<b>LARKIN GROUP, INC.</b> 8500 MENAUL, NE, SUITE A-440 ALBUQUERQUE, NEW MEXICO 87112 (505) 275-7500, FAX (505) 275-0748 PROJECT'S FILE NO. 2002-0021-15		<b>CITY OF ALBUQUERQUE</b> DEPARTMENT OF MUNICIPAL DEVELOPMENT ENGINEERING DIVISION	
<b>TITLE: CENTRAL-ATRISCO DRAINAGE IMPROVEMENTS PHASE III</b> MISCELLANEOUS DETAILS AND TYPICAL STREET SECTION			
Design Review Committee	City Engineer Approval	Mo./Day/Yr.	Mo./Day/Yr.
Project No. 6749.04		Zone Map No. K-11,J-11	Sheet 11 of 14

**RECORD DRAWING**  
APRIL 2017

**STORM DRAIN CONNECTION**

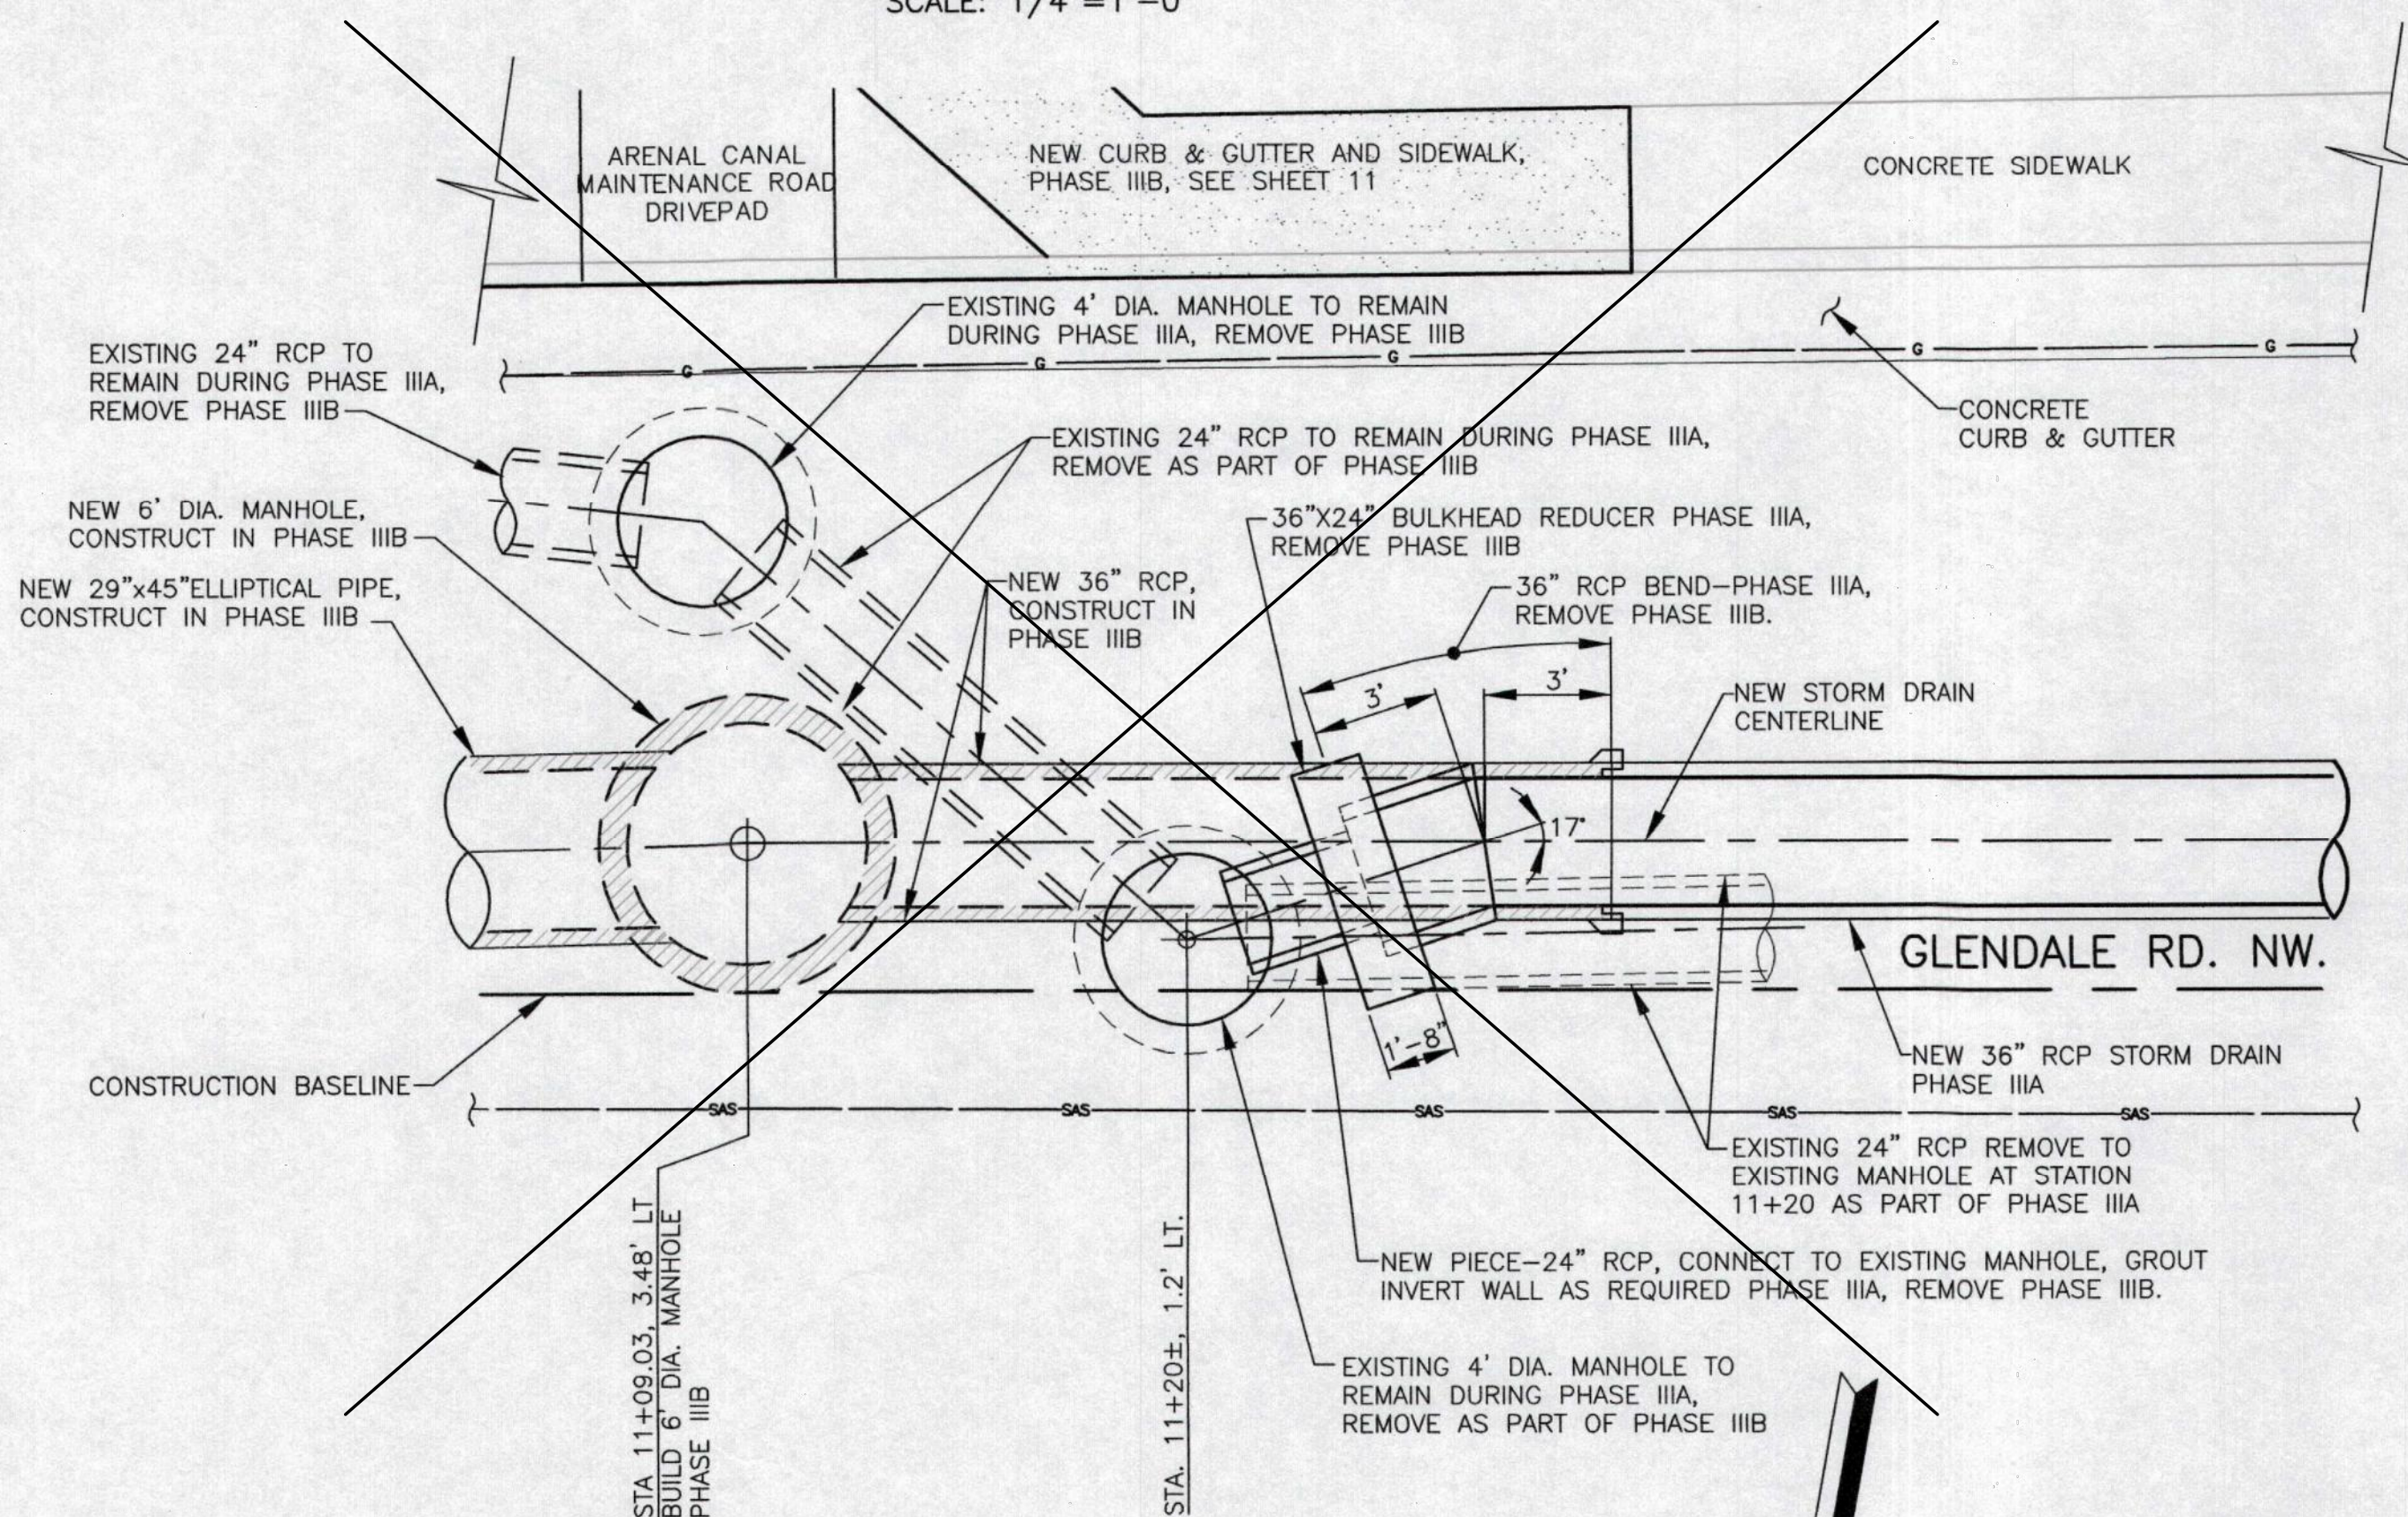
DETAIL ABOVE NOT UTILIZED. DIRECT CONNECTION MADE TO EXISTING 24" RCP W/36" RCP & COLLAR PER DETAIL BELOW
